Kirby Morgan Dive Systems, Inc.®

Bulletin #3 of 2023. April 27, 2023

CHANGE TO PRODUCT BULLETIN

**P/N 560-559 Regulator Pod for the
KM Diamond Now Machined to Include the
new P/N 810-025 Purge Valve**

The updated P/N 560-559 Regulator Pod with the machined insert for the P/N 810-025 Purge Valve.

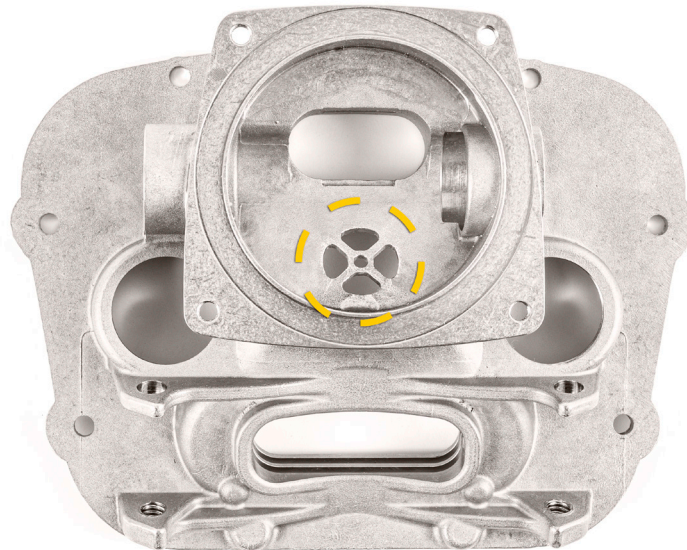
The P/N 560-559 Regulator Pod used for the KM Diamond now has a purge valve. The purge valve does not use an insert but is machined into the pod. P/N 810-025 Purge Valve is installed from the inside of the pod and can be easily viewed and inspected by removing the Regulator Cover Assembly.

Kirby Morgan will install the P/N 810-025 Purge Valve on all future production of the KM Diamond helmets.

Any old P/N 560-559 Regulator Pod stock can be used without issue.
